CPED STAFF REPORT

CPC Agenda Item #9
 September 29, 2014
 BZZ-6622

Property Location: 525 3rd Street North and 345 6th Avenue North
Project Name: Steelcase/506 4th Street North (proposed address)
Prepared By: [Janelle Widmeier](#), Senior City Planner, (612) 673-3156
Applicant: The Neat Pig Group LLC
Project Contact: Mary Springer, Snow Kreilich Architects
Request: To allow a new 4-story, nonresidential building with a plaza.
Required Applications:

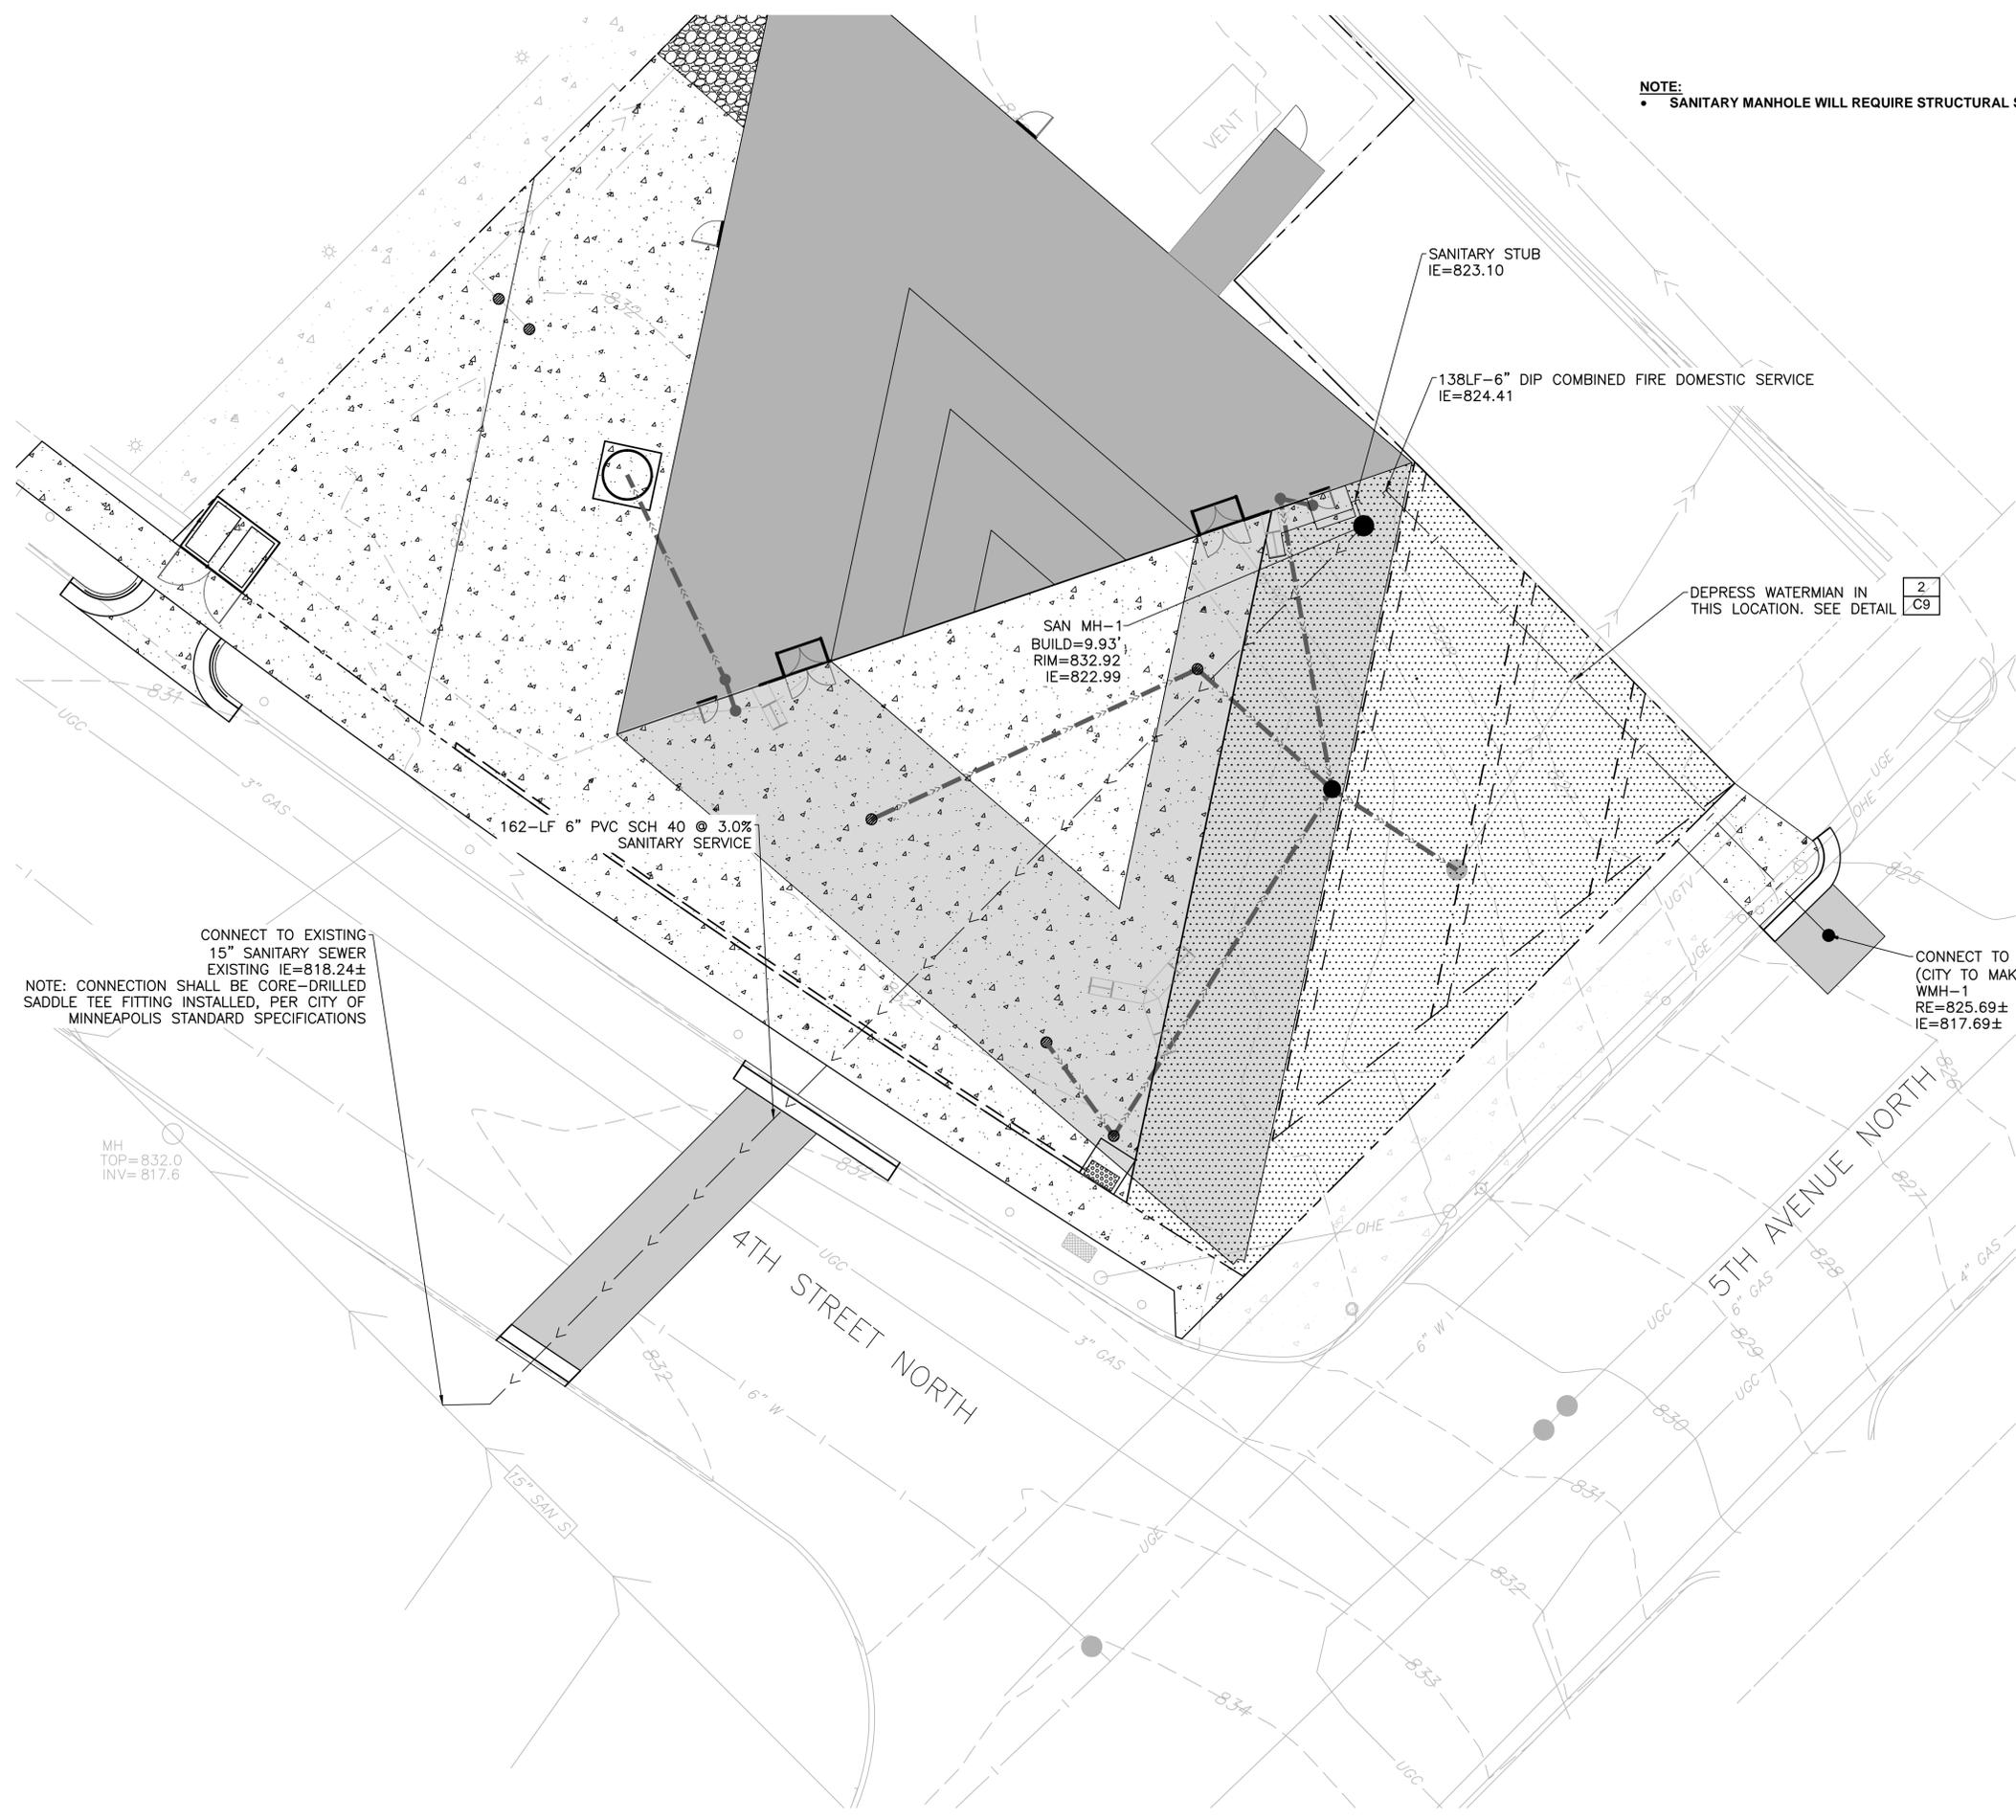
- The proposed sanitary sewer service connection to the City main should be core-drilled and a saddle tee fitting installed, per City of Minneapolis Standard Supplemental Specifications. Please note this on the plan. Please also indicate the elevation of the existing main at the connection location and pipe material on the Utility Plan. The service connection should be made in the middle third of the main.
- The existing storm sewer on the northwest side of the property, shown on Sheet C4, does not appear on the existing conditions survey. Please verify the existing storm sewer and revise the survey appropriately.

CONNECT TO EXISTING 15" SANITARY SEWER EXISTING IE=818.24±
NOTE: CONNECTION SHALL BE CORE-DRILLED SADDLE TEE FITTING INSTALLED, PER CITY OF MINNEAPOLIS STANDARD SPECIFICATIONS

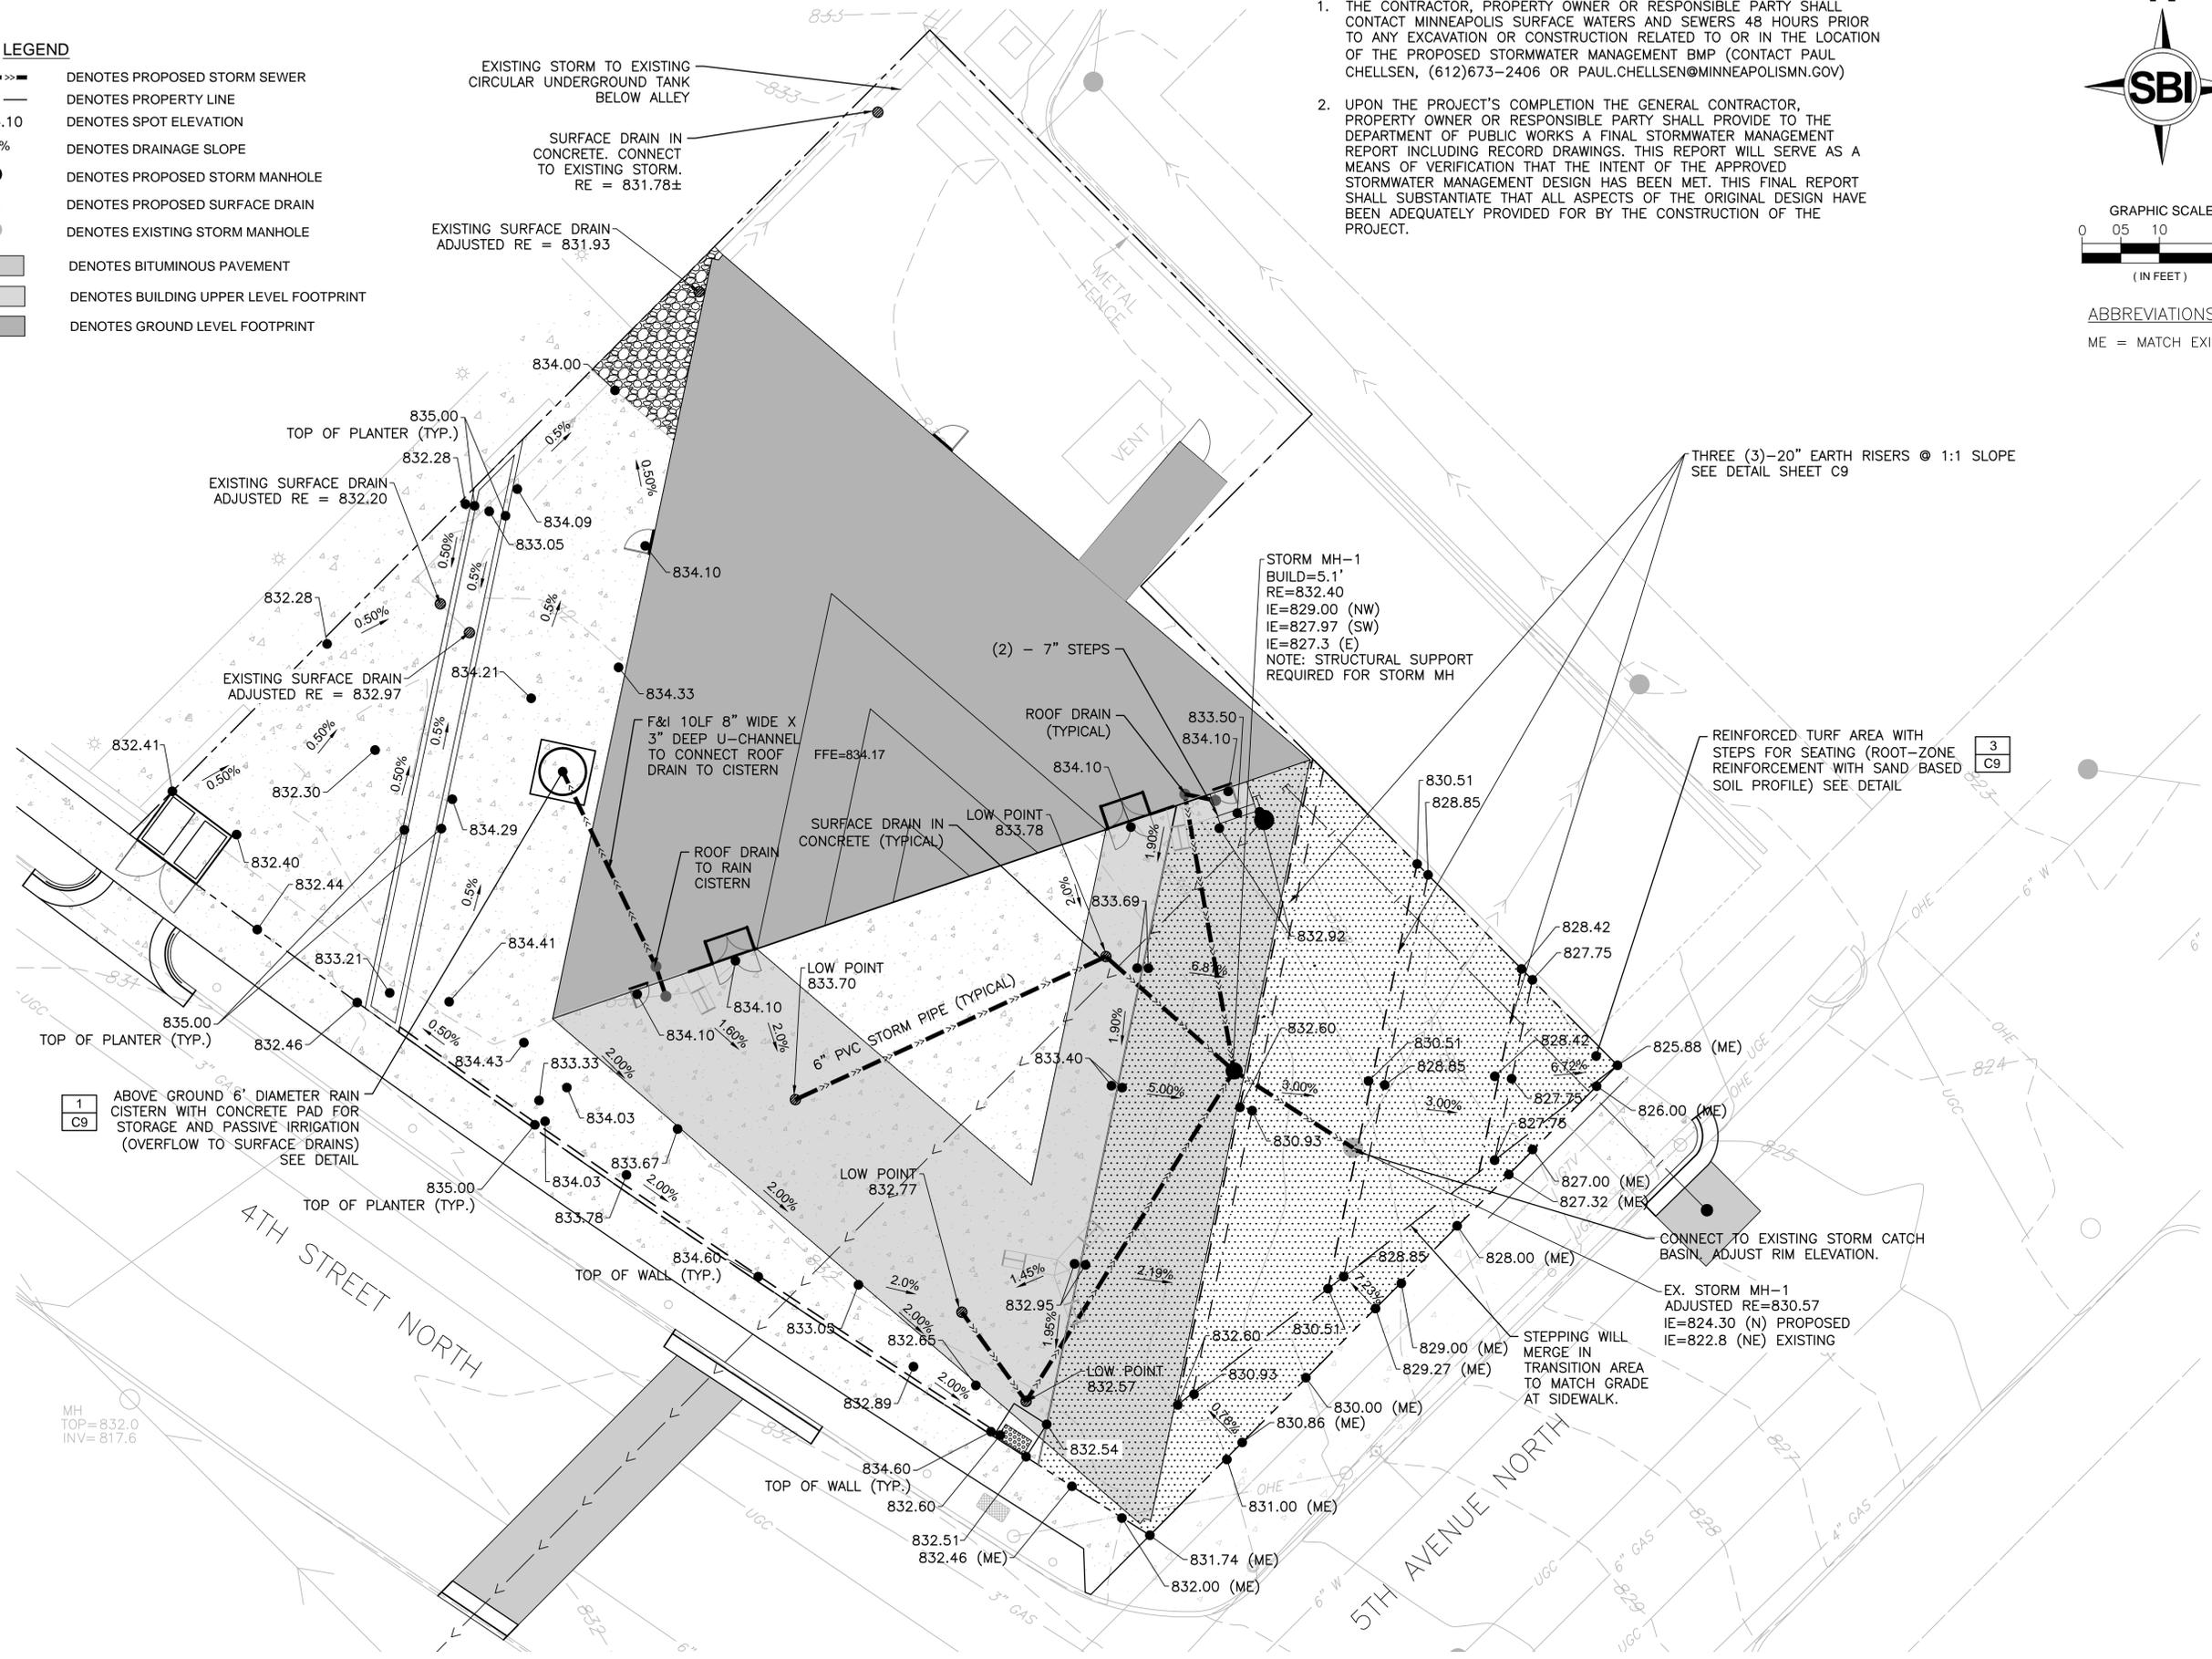
- It appears that there is some proposed grading information missing from Sheet C4. It is unclear if retaining walls are proposed or some other method is proposed to achieve the significant changes in grade in some locations. Please provide a proposed grading plan in sufficient detail to depict the proposed drainage patterns of the site. It must be demonstrated that the proposed conditions do not adversely impact adjacent properties as it relates to stormwater runoff.
